RFP 2016-0009 - ADDENDUM 3

COLIGNY REDEVELOPMENT PROJECT

Town of Hilton Head Island, South Carolina

Date Issued: August 5, 2016

6 A1.503 WINDOW DETAIL - ENTRANCE SIDE HEAD
3" = 1'-0"

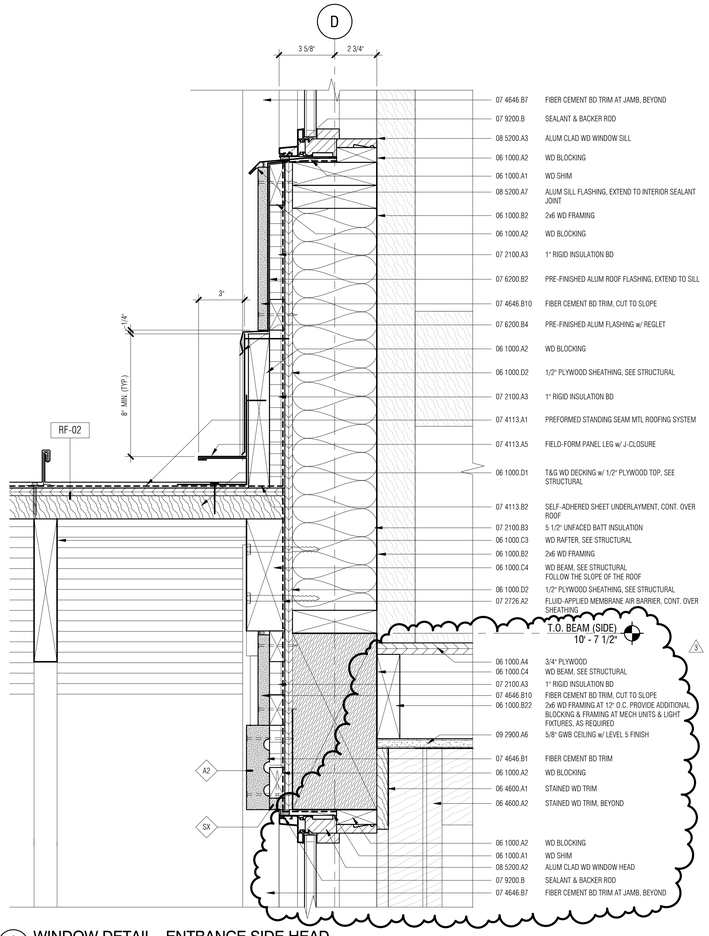
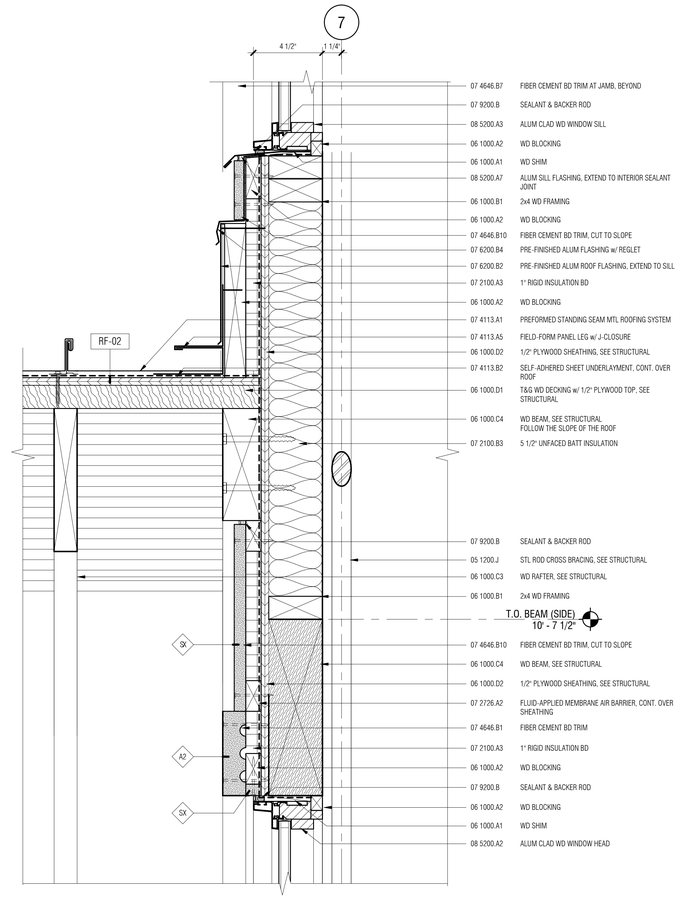
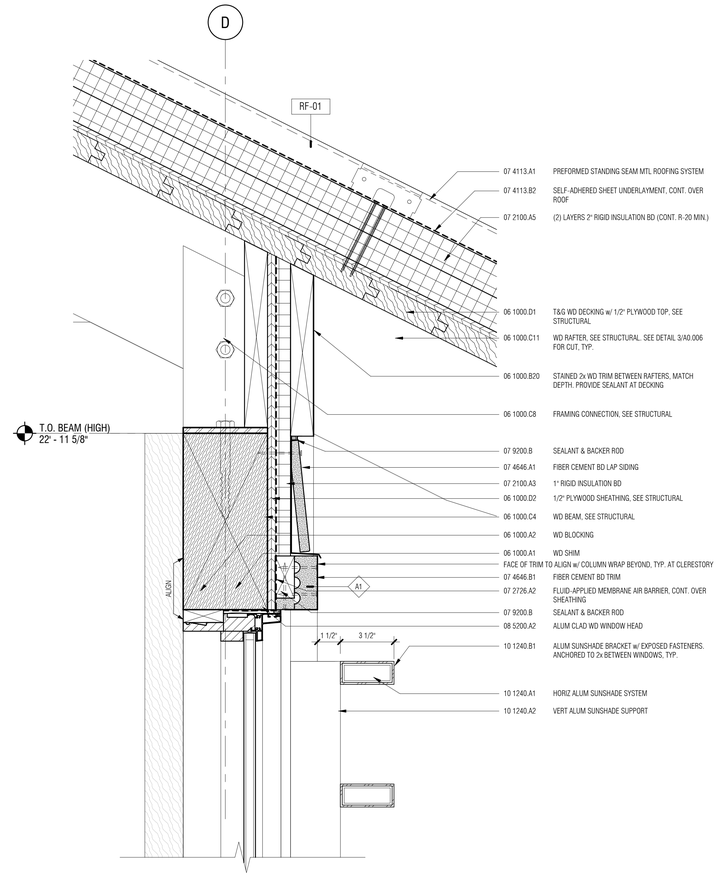
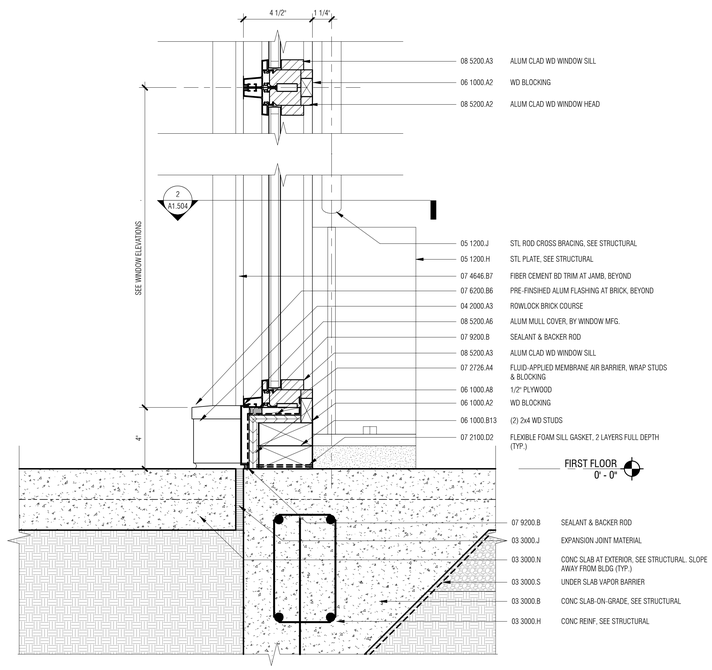
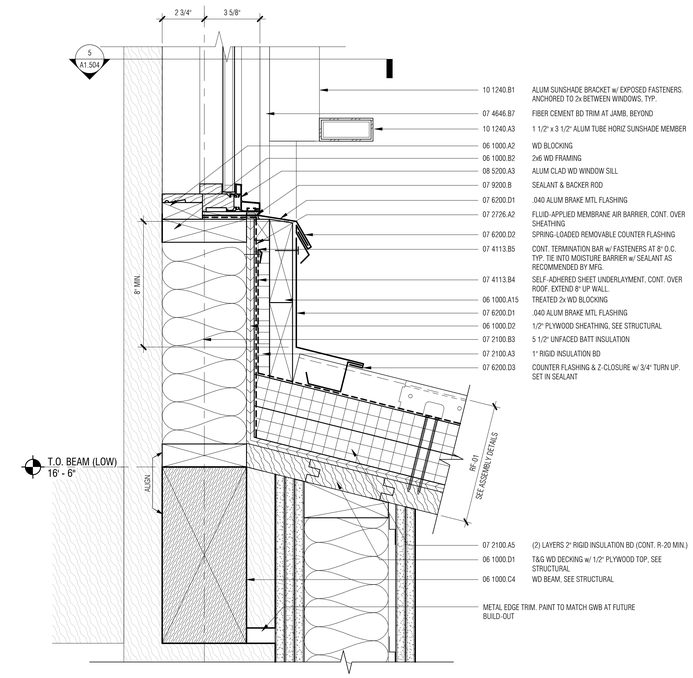
3.20 SHEET A1.503

A. Added stained wood trim and gypsum wall board ceiling and framing.

1 A1.504 PLAN DETAIL - WINDOW
3" = 1'-0"

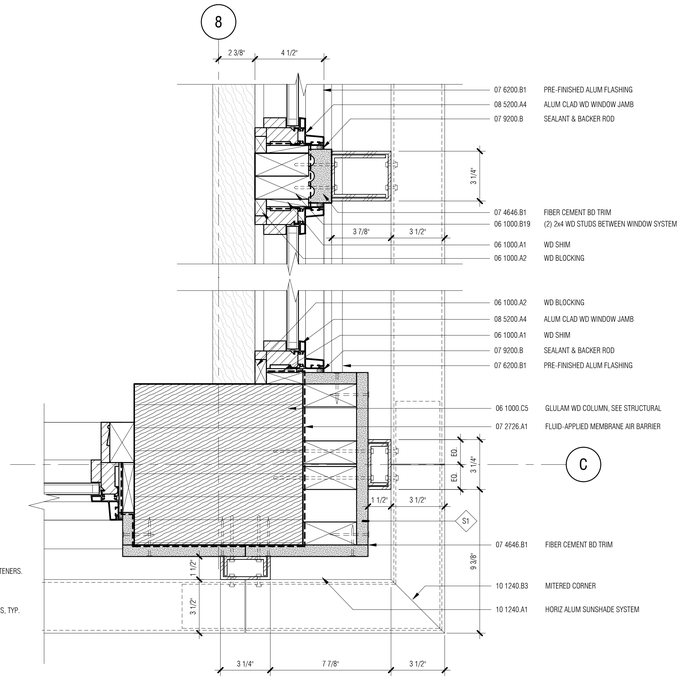
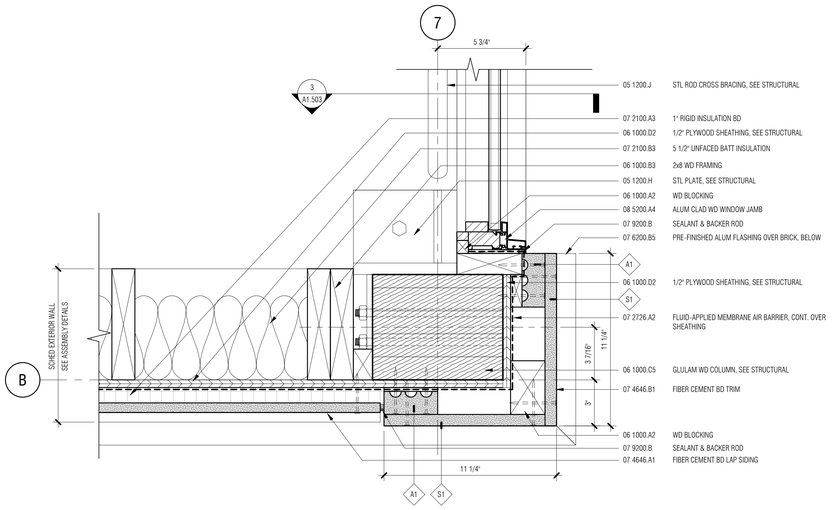
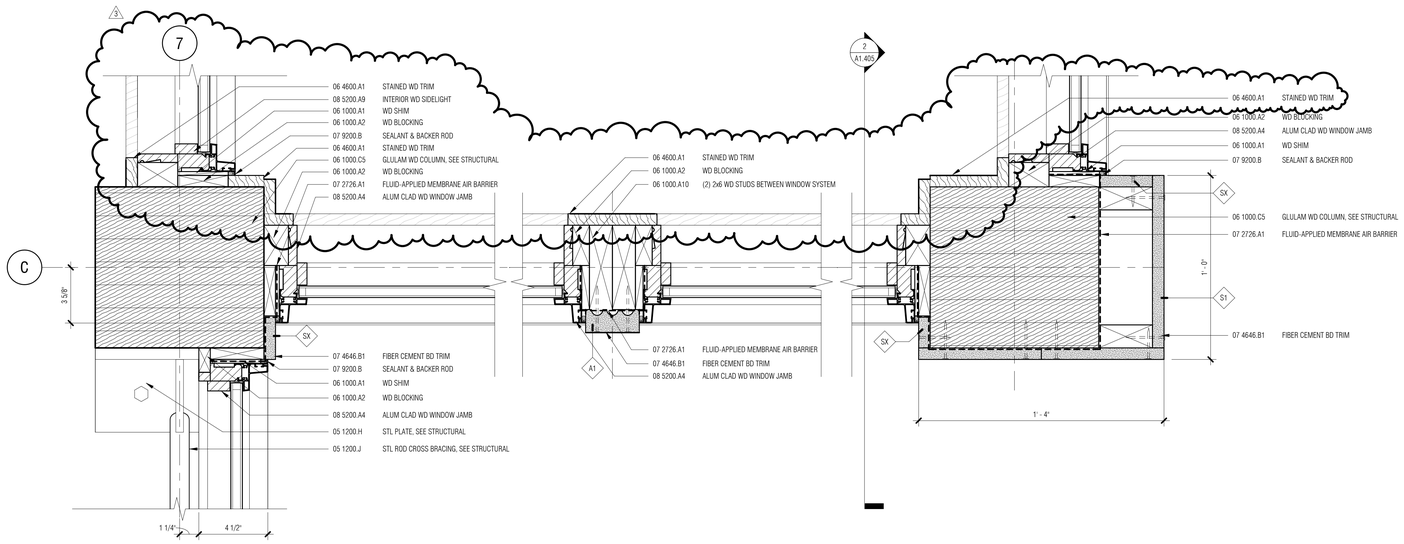
3.21 SHEET A1.504

A. Added alum window system and stained wood trim.

PLAN 1 A2.103 FLOOR PLAN - POOL RESTROOM
3/8" = 1'-0"

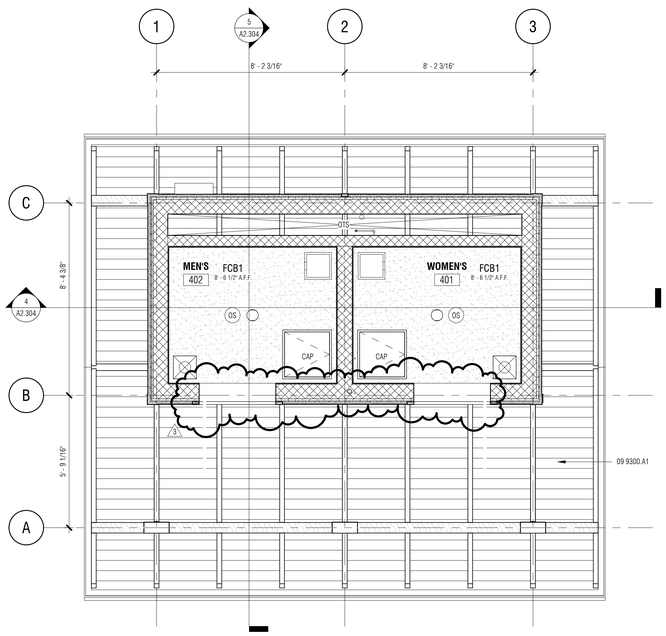
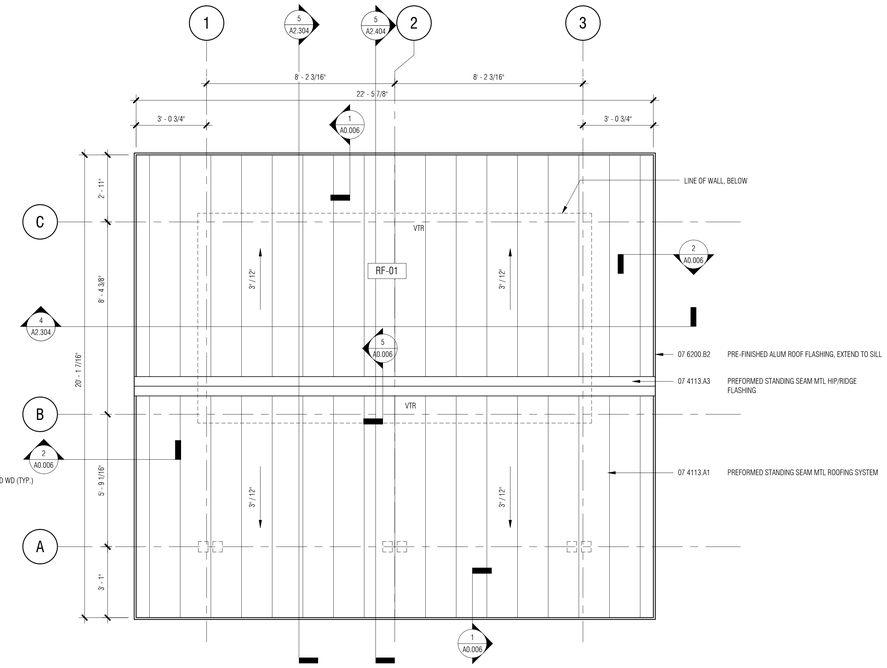
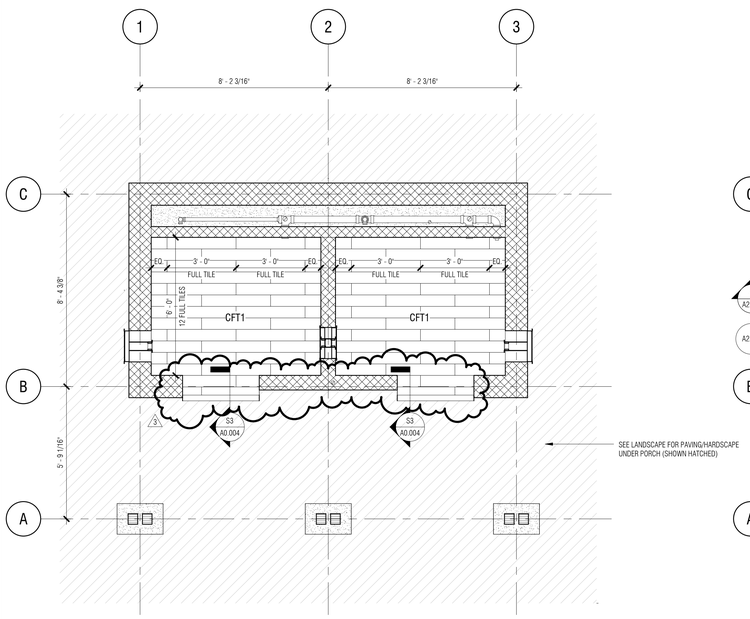
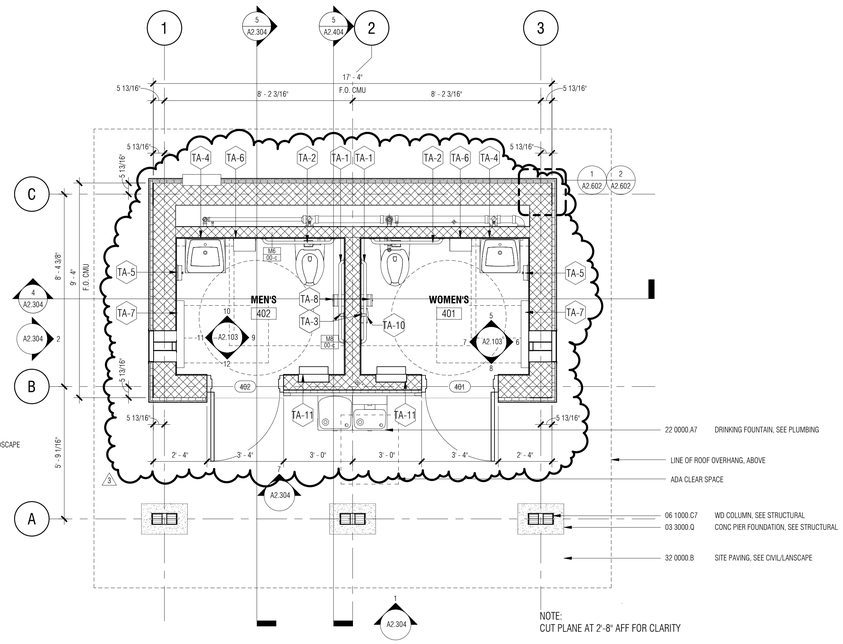
3.22 SHEET A2.103

A. Revised door locations
B. Revised Women's 401 restroom layout
C. Revised toilet accessories locations (Men's & Women's)
D. Revised Soap Dispenser Mounting Height

4 A2.404 ENLARGED ELEVATION - EAST
3/4" = 1'-0"

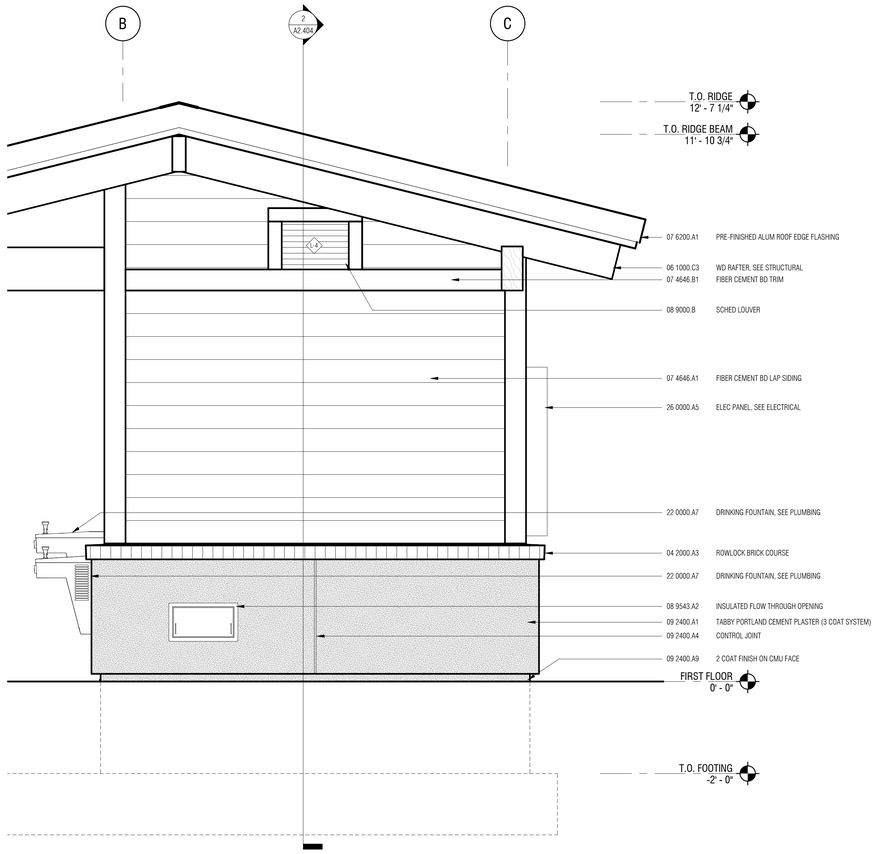
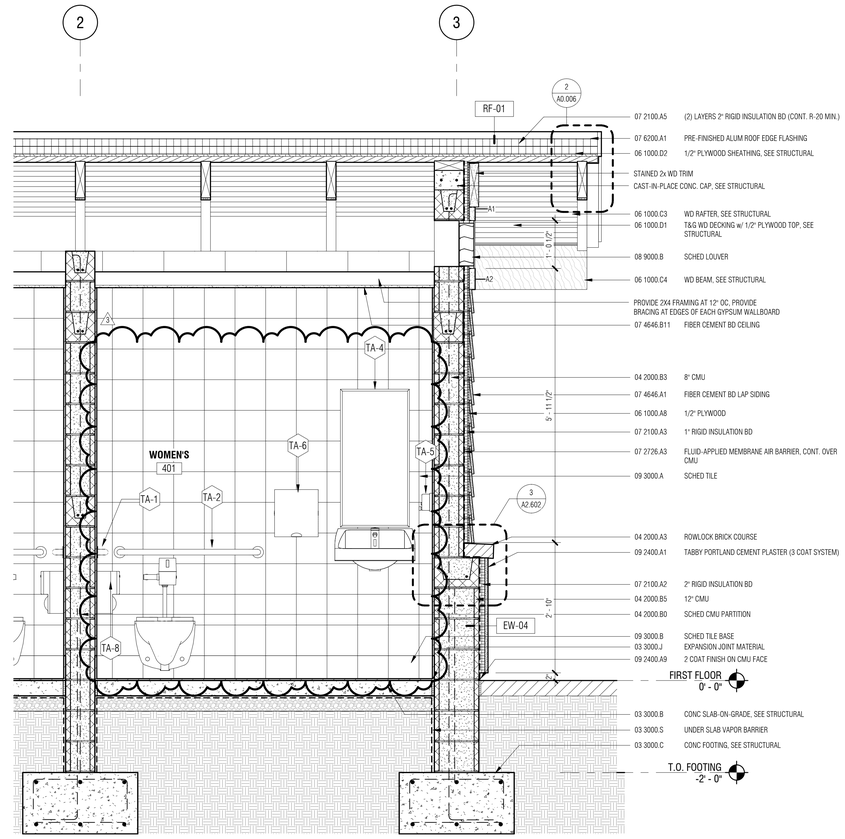
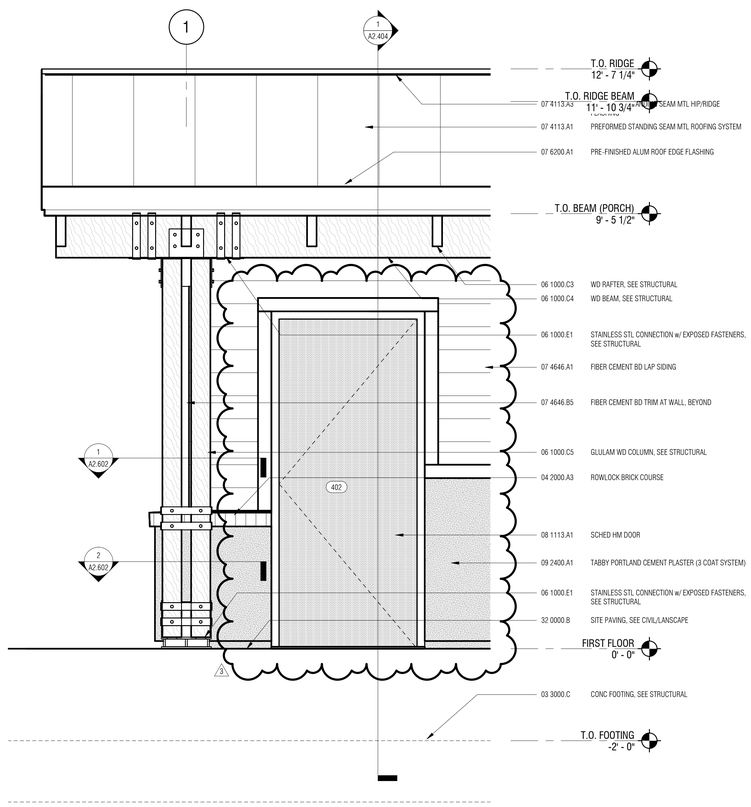
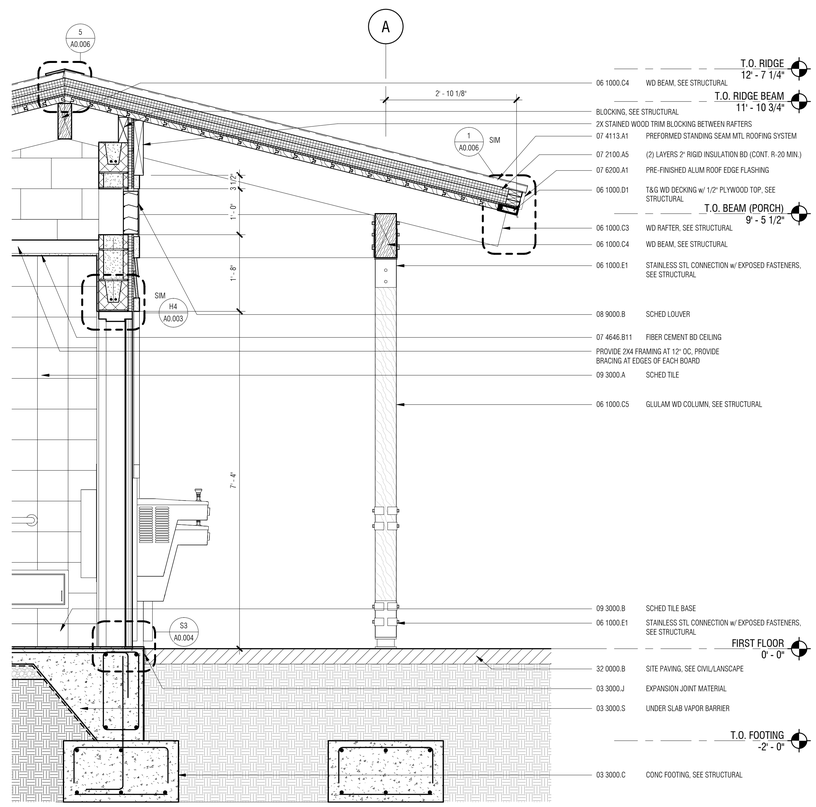
3.24 SHEET A2.404

A. Revised door locations
B. Revised Women's 401 restroom layout
C. Revised toilet accessories locations (Men's & Women's)
